Construction Traffic Management Plan

45-57 Moxon Road, Punchbowl, NSW
State Significant Development SSD-55266460

Canterbury Bankstown Council (Council) has reviewed the Construction Traffic Management Plan submitted for Post-Approval consultation, which was issued to Council on 22 July 2024. Please note that this response should be reviewed in conjunction with Council's submission for the Stormwater Detailed Design Package (PAE-73704215).

CONSTRUCTION TRAFFIC MANAGEMENT PLAN (CTMP) REVIEW		
ITEM	COUNCIL RESPONSE DATED 3.09.2024	SLR/VC RESPONSE
1	Key Considerations Council's Comments General Council notes that the Construction Traffic Management Plan does not address any public domain infrastructure improvements or upgrade works. The scope of these works, which will be required from the proponent, remains undetermined at this stage.	Please find attached site specific TGS addressing the crossover works. In addition to the TGS provided, a separate Council Work Permit will still be completed by VC for the crossover works.
2	Vehicular Access - Council notes that details regarding vehicular access have not been provided, and the previously raised comments concerning access have not be

Swept Path Assessment - B99
Central Site Access

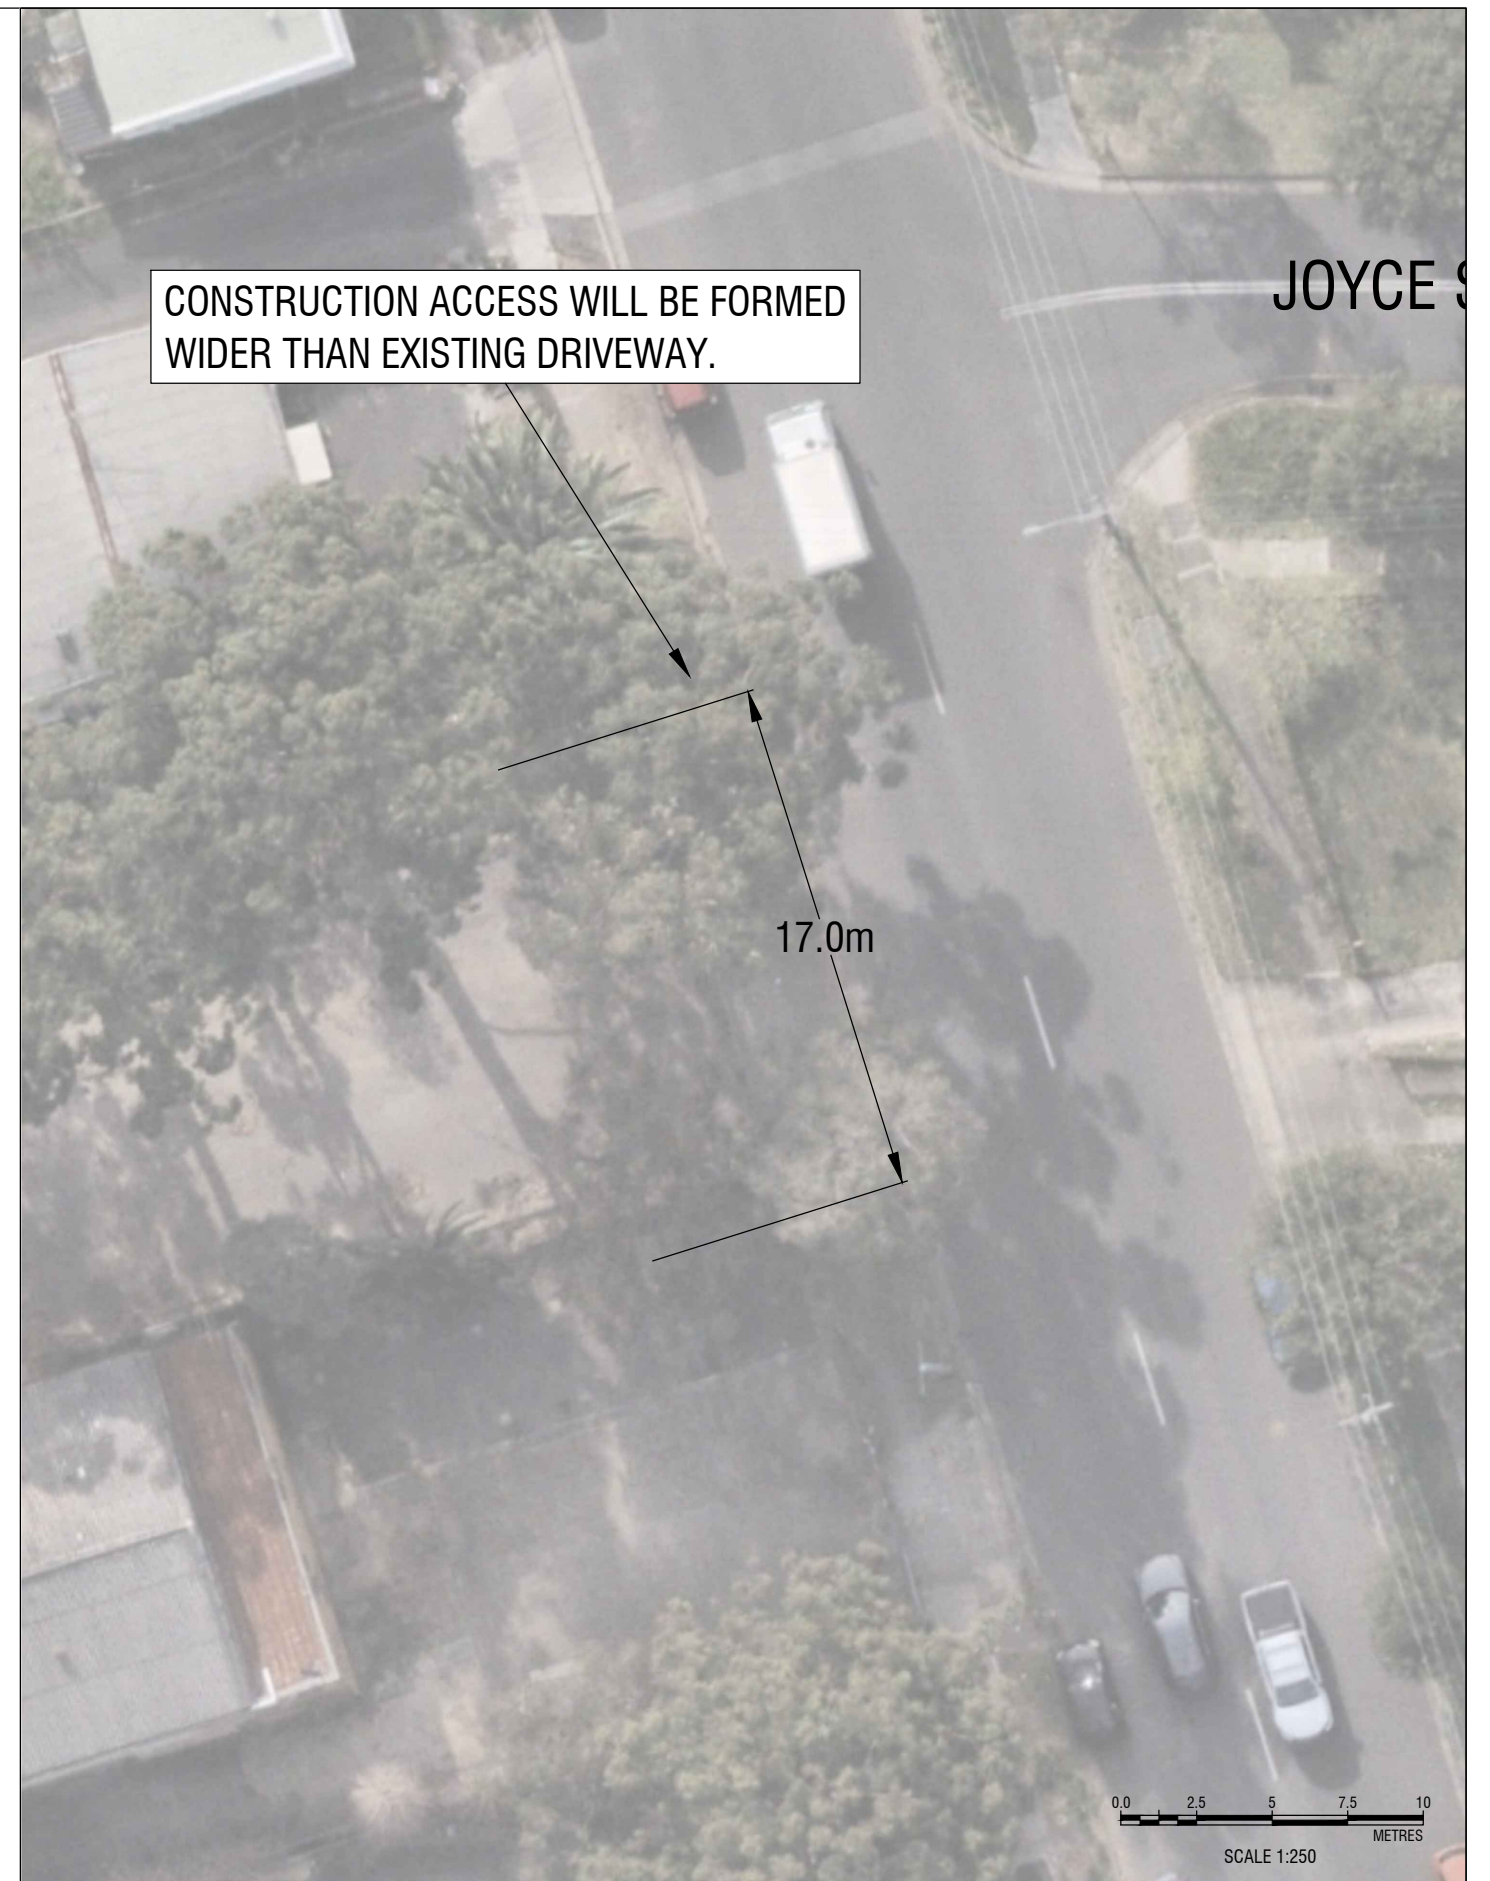
3	Traffic Guidance Scheme Council requests that a site-specific Traffic Guidance Scheme (TGS) be provided to detail the safe management of vehicle and pedestrian movements on Moxon Road, Wiggs Road, and Craig Street. Currently, only a generic/template TGS has been provided in Appendix D.	Please find attached site specific TGS for safe management of vehicle and pedestrian movements. Once the CTMP is approved, Vaughans must ensure that they comply with the approved CTMP and the requirements in it. The CTMP states that site-specific TGS plans should be provided by a traffic control company. Also note additional information has been provided under Section 5.
4	Construction Access Driveways Council requests that the location and dimensions of the proposed construction access driveways be detailed. According to the site plan in Appendix B, vehicle movements at the access point opposite Craig Street may be affected by the existing median island.	Please refer to the attached swept paths plans

**Swept Path Assessment -
Wiggs Rd / Belmore Rd**

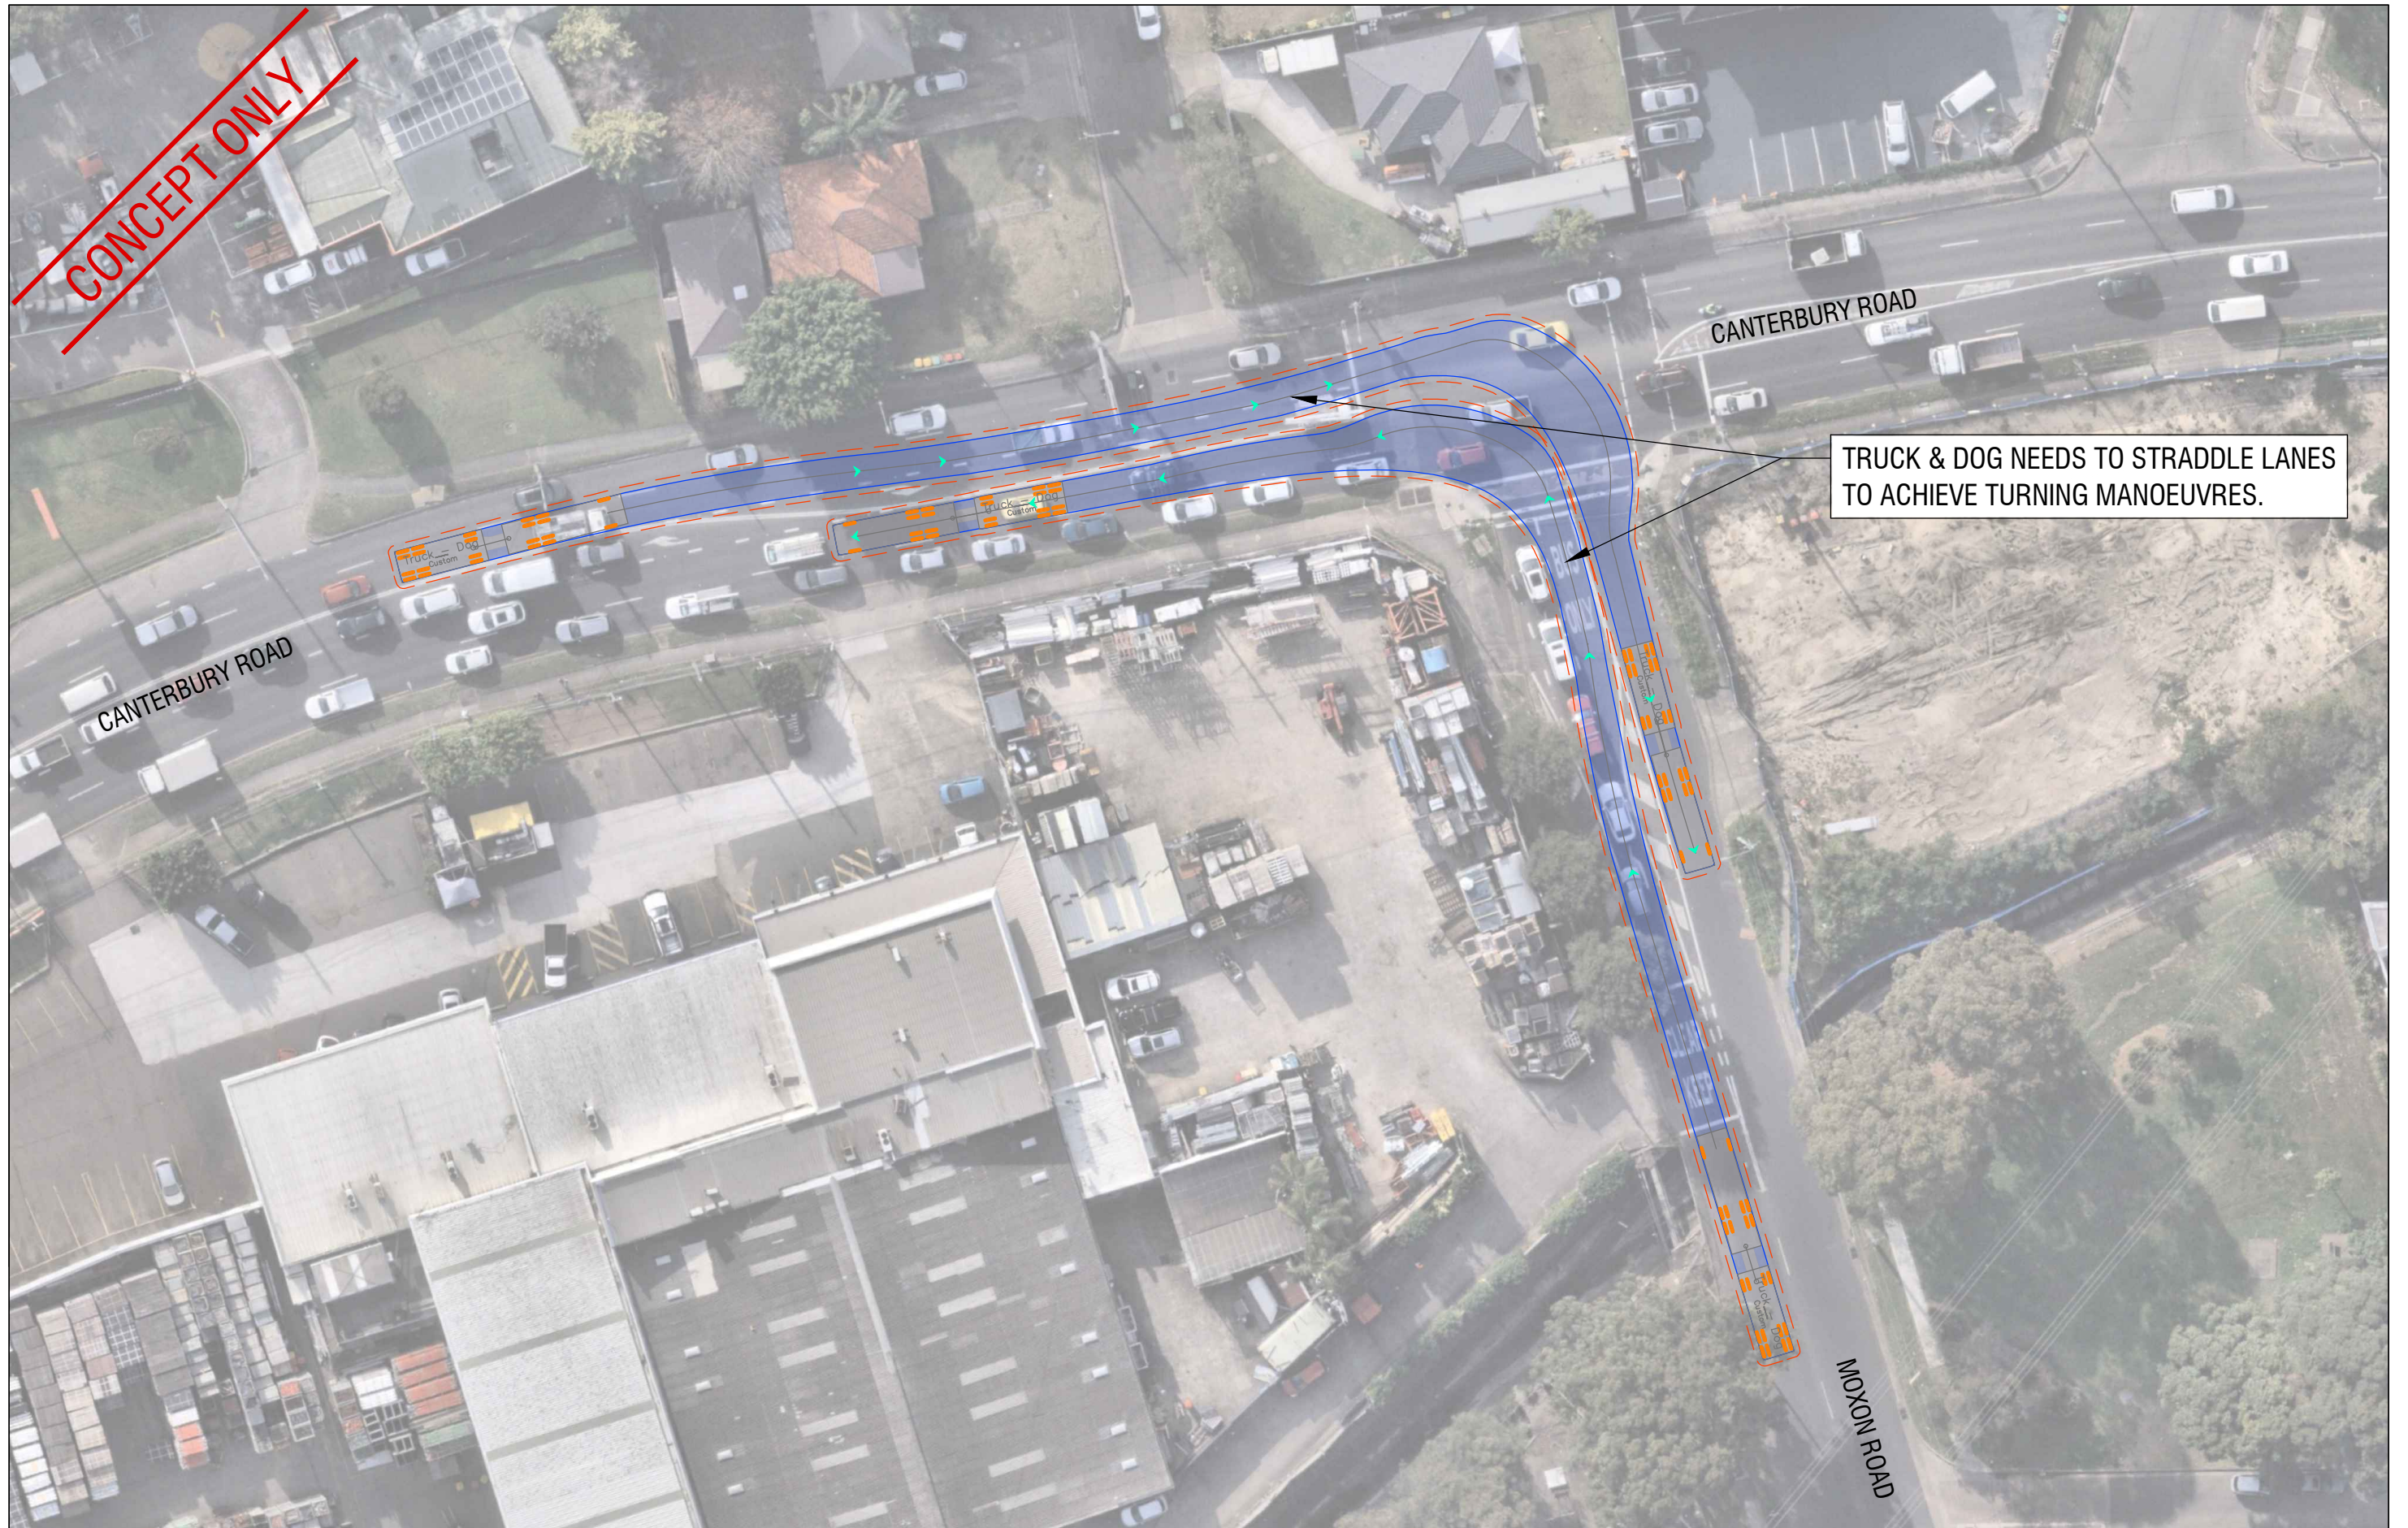
2	Wiggs Road and Belmore Road – Swept Paths - Council notes that the current signal phasing allows for both a simultaneous right turn from Wiggs Road onto Belmore Road and a left turn from Belmore Road onto Wiggs Road. - As the submitted swept paths indicate a conflict, Council requests that the maximum vehicle size utilising this intersection be reduced from a 20m Truck and Dog. Updated swept path diagrams for the revised vehicle size should be provided accordingly.	The vehicles used are General Access Vehicles (GAV) and are legally allowed to access the road network unless restricted through regulatory signage. In the case of Belmore Road and Wiggs road, there are no signs that restrict 20m truck and dog under GML limits and don't require a permit or notice to access Wiggs Road and Moxon Road. The vehicles used for site comply with the PBS Level 1 approved combinations and therefore are General Access Vehicles.

Swept Path Assessment - Truck & Dog, Canterbury Rd/Moxon Rd

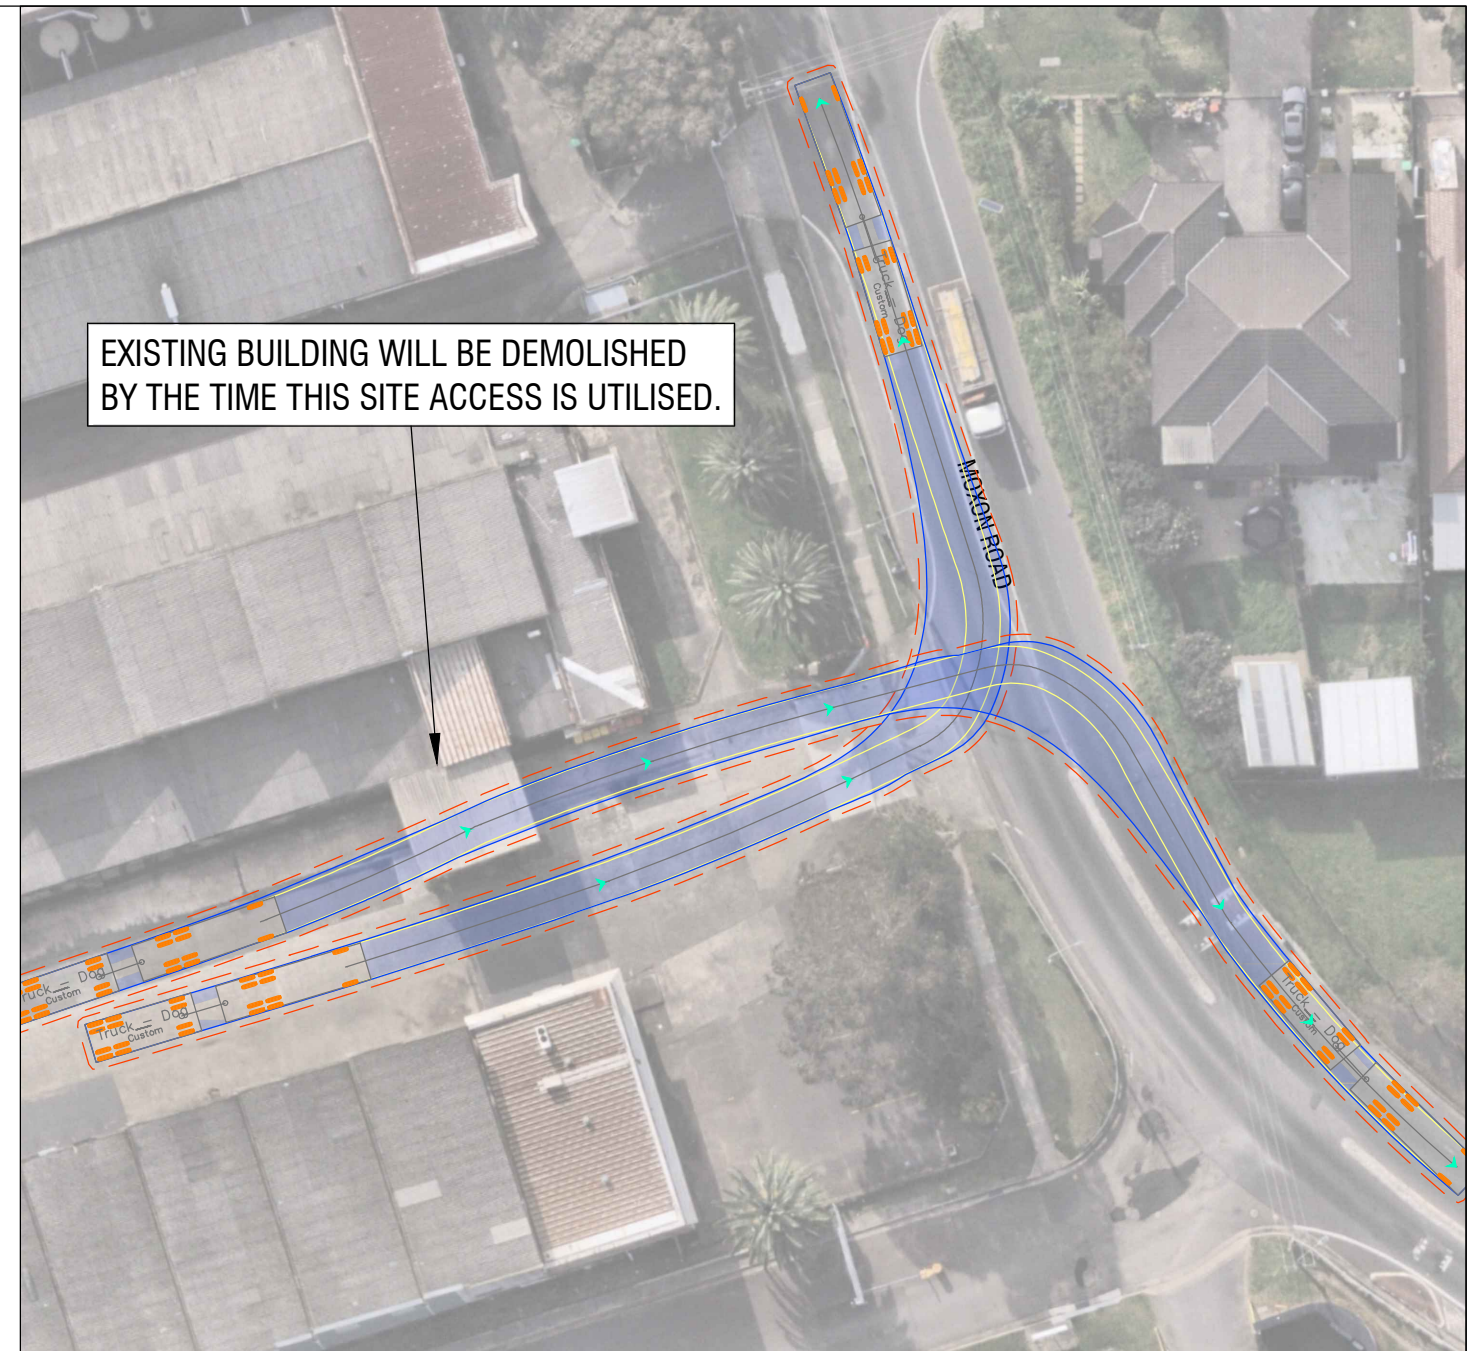
CONSTRUCTION TRAFFIC MANAGEMENT PLAN (CTMP) REVIEW		
ITEM	COUNCIL RESPONSE DATED 25.09.2024	SLR/VC RESPONSE
1	Largest Vehicle Size - Council is concerned that the 20m Truck and Dog proposed for construction exceeds the dimensions of a 19m rigid truck and trailer combination General Access Vehicle (GAV) and may not be permitted to use Moxon Road and Wiggs Road for site access. Please refer to the following for more information: https://www.nhvr.gov.au/road-access/mass-dimension-and-loading/general-access-vehicle. - Consequently, Council requests that the applicant addresses the issue regarding the use of 20m Truck and Dog vehicles to ensure compliance with access restrictions and confirm that trucks can enter the site via Moxon Road and Wiggs Road.	The vehicles used for site will comply the PBS Level 1 approved combinations and therefore are General Access Vehicles. General Access Vehicles (GAV) don't require a permit or notice to access Wiggs Road and Moxon Road; these vehicles have as-of-right access to the network as there is no signpost mentioning otherwise. The 20m Truck and Dog heavy vehicle also has applicable PBS Level 1 approved combinations, provided they do not exceed the mass limits under GML and continue to comply with all Level 1 conditions of the PBS vehicle approvals. Refer to the attached two NHVR documents which provide the following information: - Provides an information summary on general access for PBS Level 1 heavy vehicles operating at General Mass Limits. - Provides a list of common PBS vehicle configurations, including PBS Level 1 truck and dog trailer combinations with a length of 20m. VC will have fleets that are suitable for Moxon Road and Wiggs Road that comply with the PBS Level 1 approved combinations.
